2.5 Geology, Seismology, and Geotechnical Engineering

In Section 2.5, “Geology, Seismology, and Geotechnical Engineering,” of the VEGP SSAR, the applicant described geologic, seismic, and geotechnical engineering properties of the VEGP ESP site. SSAR Section 2.5.1, “Basic Geologic and Seismic Information,” presents information on geologic and seismic characteristics of the VEGP site and region surrounding the site. SSAR Section 2.5.2, “Vibratory Ground Motion,” describes the vibratory ground motion assessment for the ESP site through a PSHA and develops the SSE ground motion. SSAR Section 2.5.3, “Surface Faulting,” evaluates the potential for surface tectonic and non-tectonic deformation at the ESP site. SSAR Sections 2.5.4, “Stability of Subsurface Materials and Foundations,” 2.5.5, “Stability of Slopes,” and 2.5.6, “Erbankments and Dams,” describe foundation and subsurface material stability at the ESP site.

This SER, compiled by the NRC staff, is divided into six main sections, 2.5.1 to 2.5.6, which parallel the six main sections included in the applicant's SSAR. Each of the six SER sections is then divided into four sub-sections: (1) "Technical Information in the Application"

Figure 2.5.1-4 - Local Charleston Tectonic Features (Reproduced from SSAR Figure 2.5.1-19)

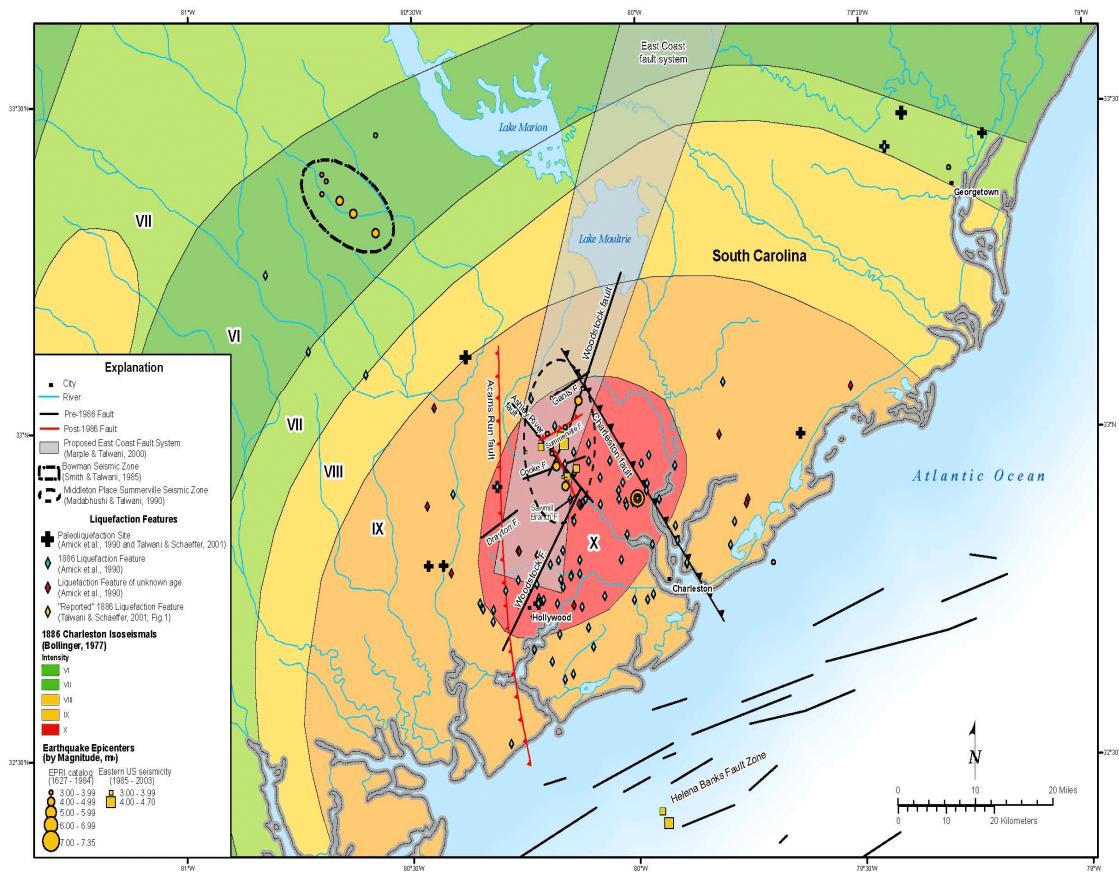
3. The applicant described the Adams Run seismic zone, located within the meizoseismal area of the 1886 Charleston earthquake as being defined by four earthquakes with magnitudes less than M2.5. Three of these four earthquakes occurred over a 2-day period in December 1977. This seismic zone occurs about 120 km (75 mi) east-southeast of the VEGP site and is not shown in Figure 2.5.1-4 as the text indicates.

**Figure 2.5.1-8 - Location of the Pen Branch Fault
(Reproduced from SSAR Figure 2.5.1-34)**

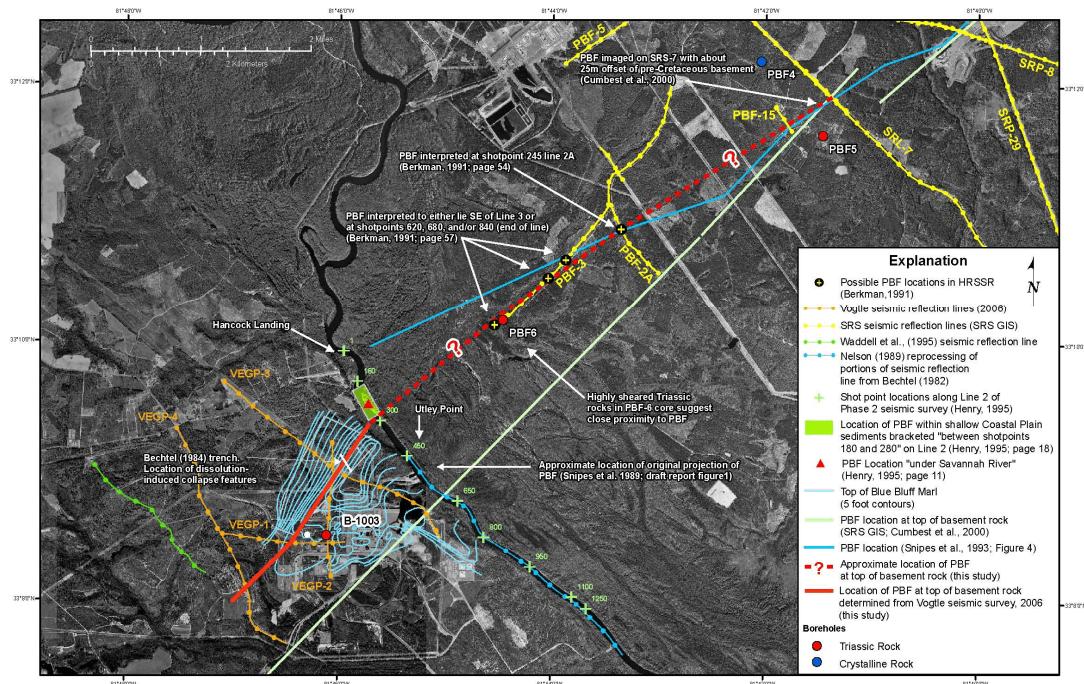
Based on an evaluation of the applicant's response, the staff concludes that, since the terraces are regional in extent, it is highly unlikely that they developed due to tectonic displacement along the Pen Branch fault. The trace of the fault is nearly perpendicular to the long axis of the terrace surfaces (see SSAR Figure 2.5.1-43), so the terraces are favorably oriented to register Quaternary deformation along the Pen Branch fault. Alternatively, the staff believes a more likely origin for the terraces involves regional changes in sea level relative to the continental land mass. These regional changes resulted from either climatic, isostatic, or eustatic effects or some combination of these nontectonic mechanisms. Climatic, isostatic, and eustatic perturbations alter sea level relative to the land mass on a regional scale, either by raising the sea level itself (climatic and eustatic changes) or isostatically uplifting blocks of continental crust due to regional crustal unloading (isostatic changes). The mechanism of tectonic perturbations is separate and distinct from these regional changes in sea level and would involve tectonic uplift (e.g., fault displacement) to raise a fault block and produce abandoned fluvial terraces atop that block. The staff's conclusion that the fluvial terraces developed as a result of nontectonic processes rather than by tectonic uplift is based on the staff's evaluation of the

Figure 2.5.2-2 - Alternative geometries comprising the UCSS model updated Charleston seismic source (reproduced from SSAR Figure 2.5.2-9)

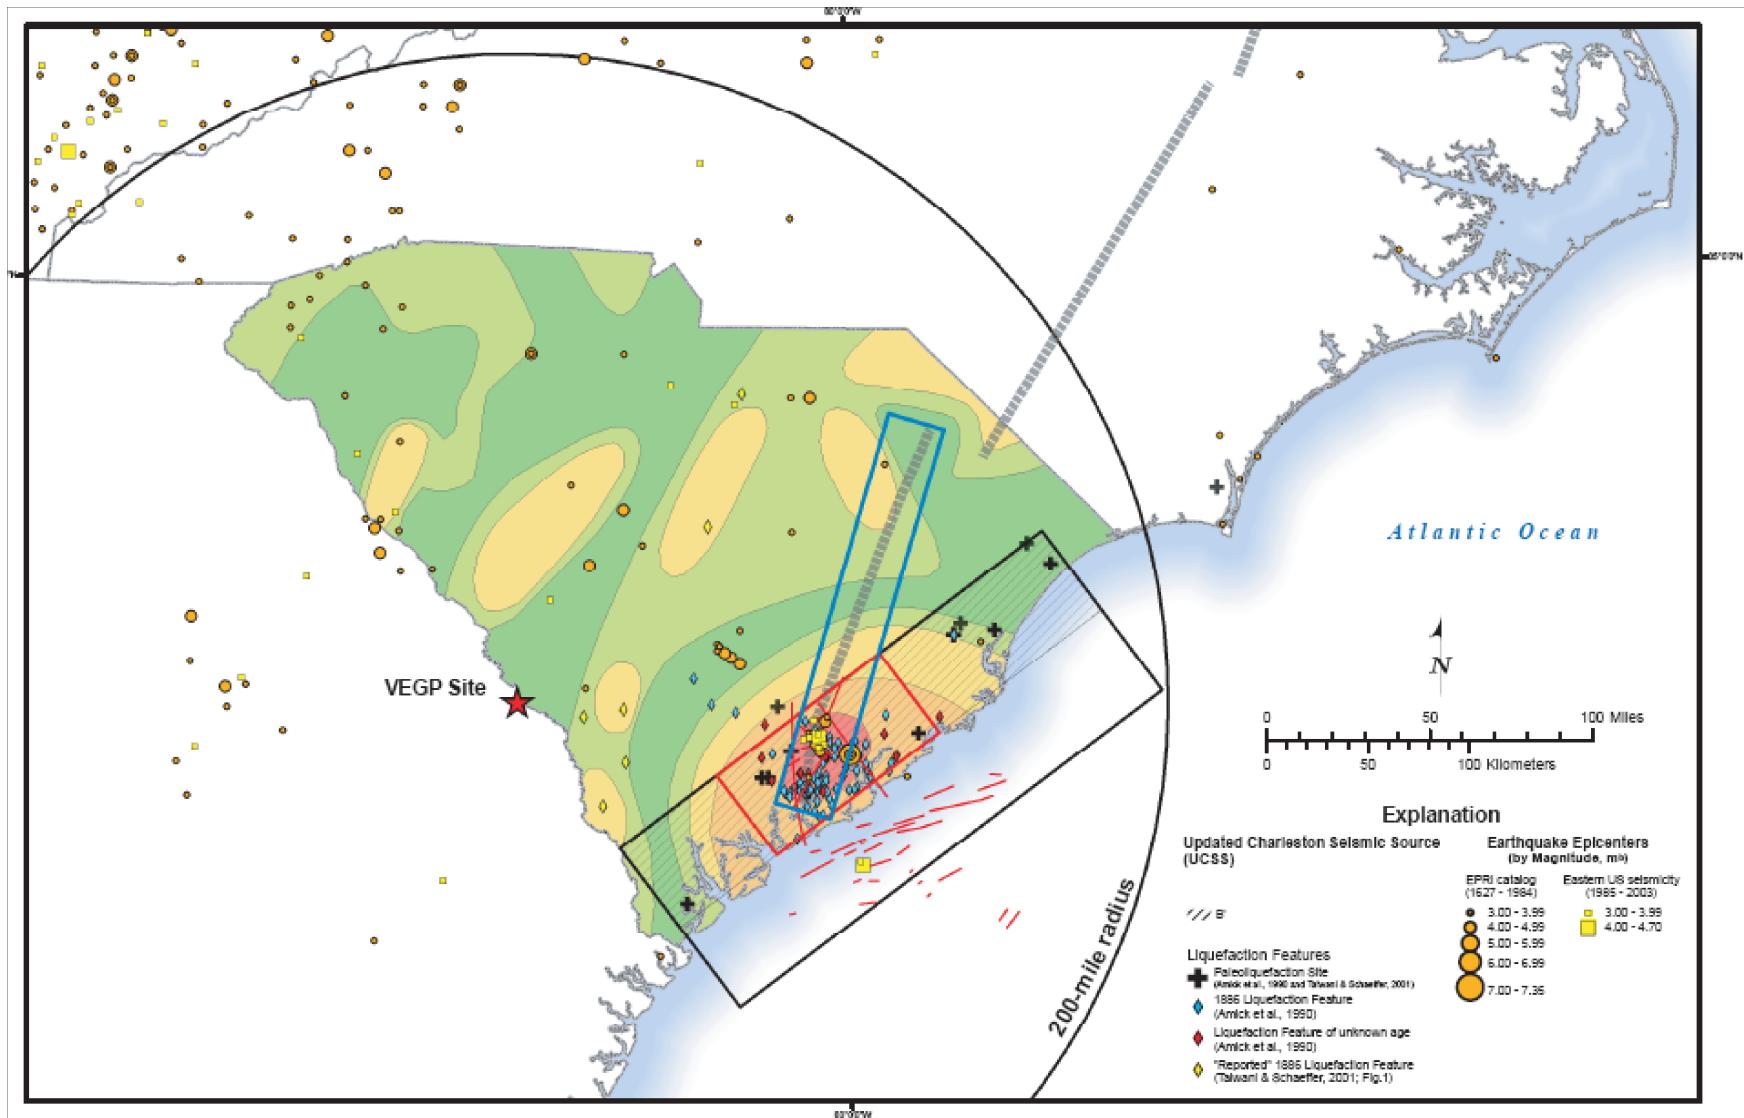
Charleston Seismic Source Zone Geometries. For its update of the Charleston seismic source zone, the applicant developed new source zone boundaries. Specifically, as described in SSAR Section 2.5.2.2.4, the applicant developed four, mutually exclusive source zone geometries, referred to as A, B, B', and C, to represent the Charleston seismic source. These four source zones are shown in SER Figure 2.5.2-2 (reproduced from SSAR Figure 2.5.2-9). SSAR Section 2.5.2.2.4.1 states that the width of Geometry B is 80 kilometers (50 miles). However, SSAR Figure 2.5.2-9 (and SER Figure 2.5.2-2) show that

the width of Geometry B is 100 kilometers (62 miles). In RAI 2.5.2-14, the staff asked the applicant to provide the actual dimensions of Geometry B used for the UCSS. In response, the applicant stated that the width of UCSS Geometry B is 100 kilometers and not 80 kilometers, as stated in SSAR Section 2.5.2.2.4.1. Based on the applicant's clarification of the width of source zone B, the staff concludes that the source referred to as Geometry B in SSAR Figure 2.5.2-9 is accurate.

Figure 2.5.2-11 - Comparison of the staff's 1-Hz hazard curves for the ETSZ for magnitudes ranging from M 6.0 to M 7.8

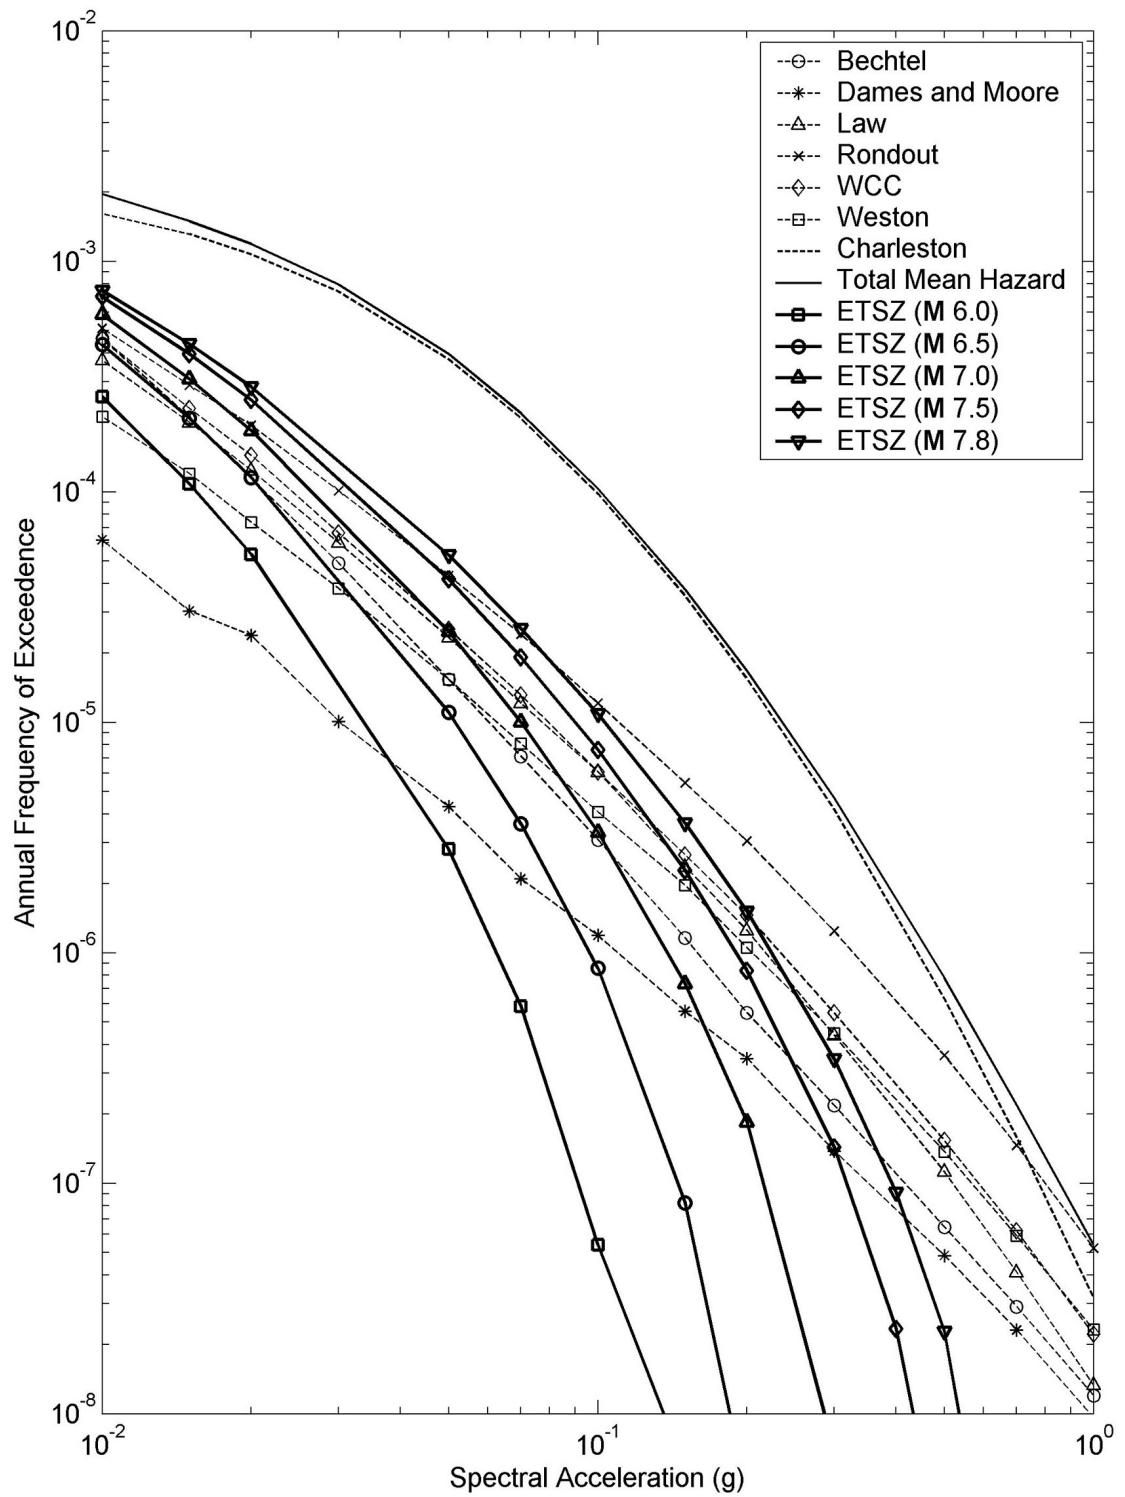
To validate the applicant's claim that the ETSZ hazard results are insignificant compared to the Charleston seismic source, the staff did a confirmatory analysis. The staff performed hazard calculations using maximum magnitudes for the ETSZ that ranged from M 6.0 to M 7.8. This magnitude range reflects more recent M_{max} values assigned to the ETSZ, as shown in SER Table 2.2.5-6. SER Figure 2.5.2-11 shows the staff's 1-Hz hazard curves for the ETSZ using this range of M_{max} values. SER Figure 2.5.2-11 also shows the applicant's total mean hazard curve and the Charleston seismic source zone contribution for comparison. The staff's results show that, although the Charleston seismic source zone clearly dominates the 1-Hz hazard, the contribution from the ETSZ for some of the larger M_{max} values (greater than 7.0) may contribute significantly more than 1 percent to the total hazard for the ESP site.

The staff concludes that, despite the uncertainty regarding the potential for large earthquakes within the ETSZ, the results of post-EPRI source characterizations for the ETSZ suggest that the EPRI EST characterization of the ETSZ needs to be updated. The results of the staff's confirmatory analysis do confirm the applicant's assertion that the Charleston seismic source dominates the 1-Hz hazard. However, the staff concludes that the contribution of the ETSZ at the ESP site may be significant enough to warrant inclusion in the applicant's PSHA, if larger M_{max} values are considered. This is **Open Item 2.5-3**.

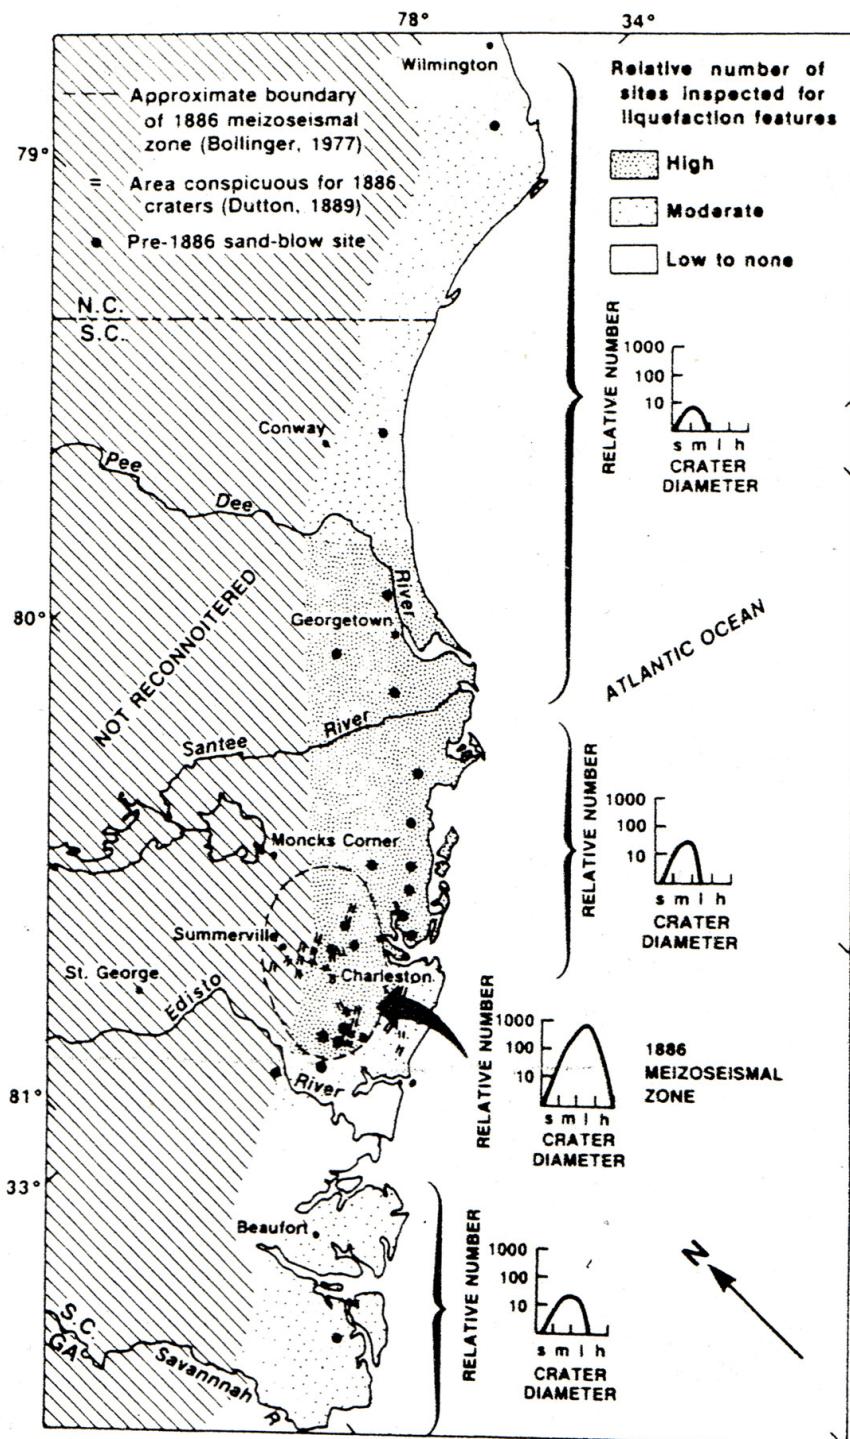
The staff also reviewed the study of Obermeier et al. (1989). Obermeier et al. (1989) conclude that, "Both the size and relative abundance of pre-1886 craters are greater in the vicinity of Charleston (particularly in the 1886 meizoseismal zone) than elsewhere, even though the susceptibility to earthquake-induced liquefaction is approximately the same at many places throughout this coastal region." Figure 4 of Obermeier et al. (1989), reproduced as SER Figure 2.5.2-12, depicts the sizes of various prehistoric liquefaction features and demonstrates that the largest craters of all ages concentrate near Charleston. The staff notes that the figure cannot exclude the possibility that one (or more) of the large prehistoric earthquakes created its (or their) largest liquefaction features elsewhere. However, Obermeier's (1989) figure shows four size classes of craters, with the largest prehistoric craters (wider than 3 meters) present only in the 1886 meizoseismal area. Only smaller craters are known farther south and north. Obermeier (1989) favors attributing some of these distant, small-to-medium-sized craters to infrequent moderate earthquakes at two separate sources far north and south of Charleston. The epicentral regions of 1886-sized earthquakes should have abundant craters wider than 3 meters, and they have been found only near Charleston. Sparse exposures preclude saying much about crater sizes between Beaufort and the Edisto River, south of Charleston (Obermeier et al. 1989) and south of Geometry A. Thus, it is unlikely, but possible, that the paleoliquefaction record of a large earthquake's meizoseismal region could be concealed south of Geometry A. However, this small probability is accounted for by Geometries B and B', which span most of the length of South Carolina's coast. The absence of known abundant paleoliquefaction features in North Carolina and Georgia, despite searches there (Amick and Gelinas 1991), suggests that Geometries B and B' need not extend beyond South Carolina.

(62 miles) inland from the coast. The occurrence of a large earthquake inland of the coast would necessitate different Charleston source zone models. See Open Item 2.5-5.

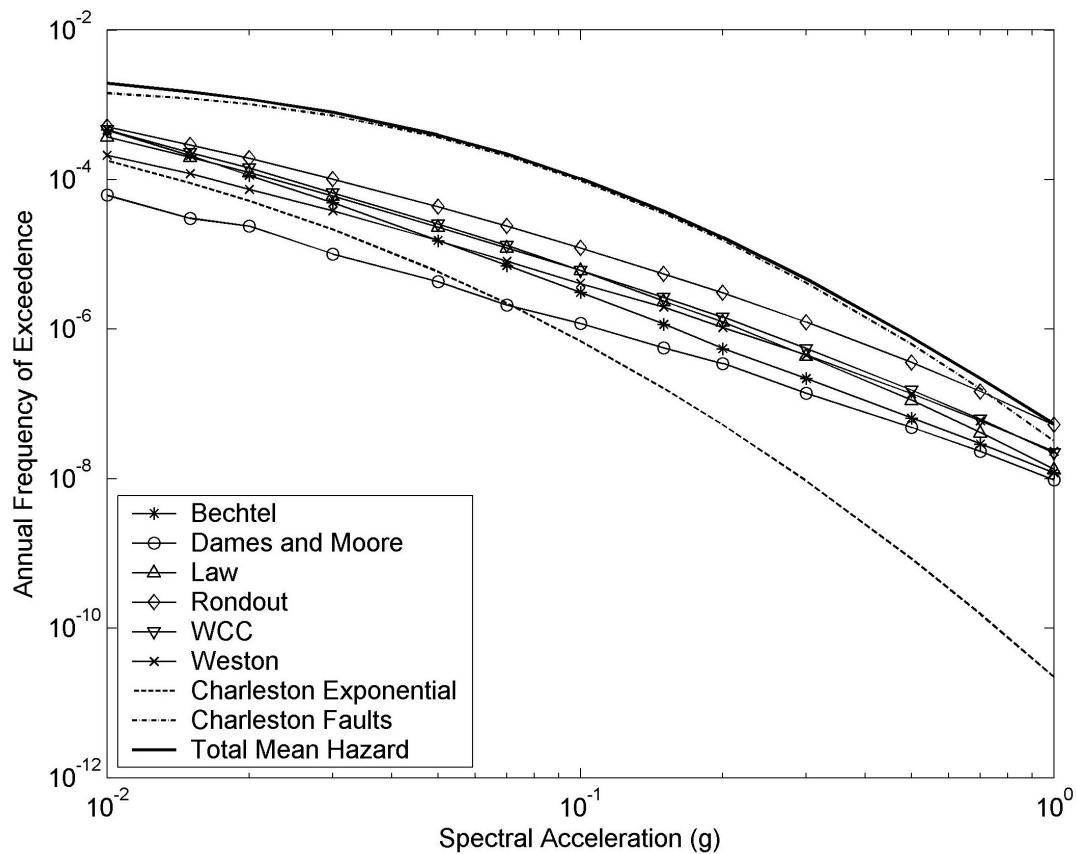
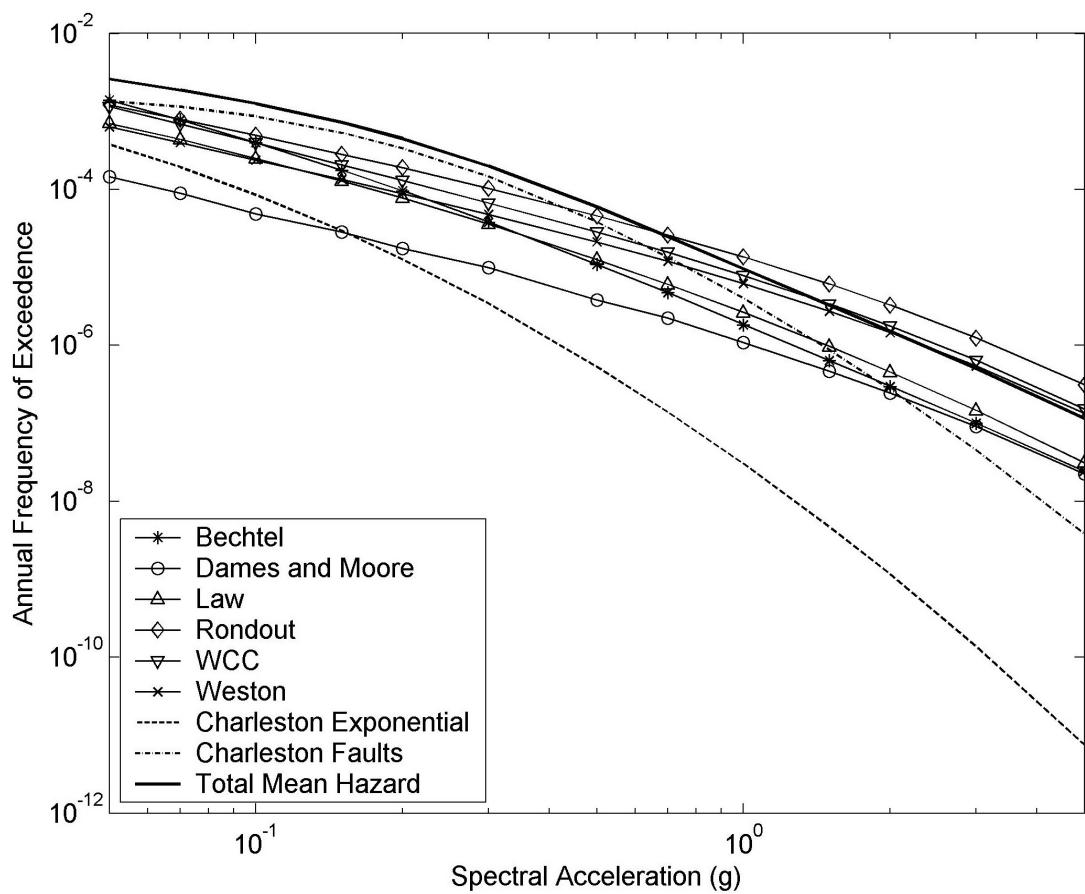
In order to determine the adequacy of the PSHA results, the staff, in RAI 2.5.2-1, requested the applicant to provide the 1- and 10-Hz mean hazard curves for each of the six EPRI ESTs, as well as the 1- and 10-Hz mean hazard curves for the UCSS model. In response to RAI 2.5.2-1, the applicant provided the requested hazard curves. SER Figures 2.5.2-13 and 2.5.2-14 show the applicant's 1-Hz and 10-Hz total mean hazard curves, as well as the hazard curves corresponding to each of the six EPRI EST seismic source model inputs. Both figures also show the hazard curves corresponding to the applicant's UCSS model.

As shown in SER Figure 2.5.2-13, for the 1-Hz hazard curves, the Charleston source dominates the overall hazard at the ESP site. In SER Figure 2.5.2-14, for the 10-Hz hazard curves, the contributions from each of the six ERPI seismic source models have a more significant contribution to the overall hazard.
